# Access Compliance Report Public Rights-of-Way (Curb Ramps)

Intersection ID: 27189	Main Street: MCKEE_RD	Cross Street: PROVIDENCE_ARBOURS_DR	Location: NE
ADA ID: 5E997A64AB2A	Ramp Type: BlendTrans1	Initial Pass/Fail: Fail	Overall Compliance: No Severity Score: 21.25

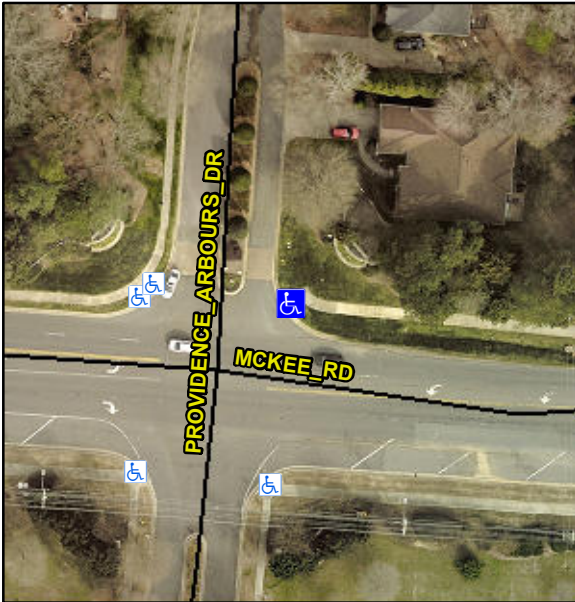
PROW/ADA:  
**Not Found, R304.5.1, R304.5.3**

Compliance	Description	Data	Compliance	Description	Data
N/A	Ramp Length (in)	96.0	Yes	BlendTrans Slope (%)	4.5
No	Ramp Width (in)	47.0	No	BlendTrans XSlope (%)	5.2
N/A	Flare Type LT	N/A	N/A	Flare Type RT	N/A
N/A	Flare Slope LT (%)	N/A	N/A	Flare Slope RT (%)	N/A
N/A	Flare Traversable LT?	N/A	N/A	Flare Traversable RT?	N/A
N/A	Landing Length (in)	N/A	N/A	DWS Provided?	N/A
N/A	Landing Width (in)	N/A	N/A	DWS Contrast?	N/A
N/A	Landing Slope (%)	N/A	N/A	DWS Length (in)	N/A
N/A	Landing X Slope (%)	N/A	N/A	DWS Full Width?	N/A
N/A	Landing Curb? (Y/N)	N/A	N/A	DWS Offset (in)	N/A
N/A	Shared Landing?	N/A			
N/A	Gutter Ponding?	N/A	N/A	Gutter Slope (%)	N/A
N/A	Gutter Lip Ht (in)	N/A	N/A	Gutter X Slope (%)	N/A
N/A	Painted X Walk1?	No	N/A	Painted X Walk2?	No
	X Walk 1 Direction	To W		X Walk 2 Direction	To S
	X Walk 1 Width (in)	N/A		X Walk 2 Width (in)	N/A
	X Walk 1 Slope (%)	1.6		X Walk 2 Slope (%)	5.8
	X Walk 1 X Slope (%)	5.8		X Walk 2 X Slope (%)	0.1

N/A	Ramp inside XWalk1?	N/A	N/A	Ramp inside XWalk2?	N/A
	Road Slope (%)	4.5		Clear Space?	N/A
	Road X Slope (%)	3.8	N/A	Clear Space to XWalk (in)	N/A
N/A	Any Obstructions?	N/A	N/A	Storm Grate/Utility Hazard?	N/A
	Obstruction Type			Storm Grate/Utility Type	
		N/A			N/A
Yes	Surface Condition? (G/P)		Yes		Good
No	Curb Slope (%)		No		7.6

Possible Solutions:  
**Remove & Replace Curb Ramp With Two New Directional Ramps or Equivalent.**
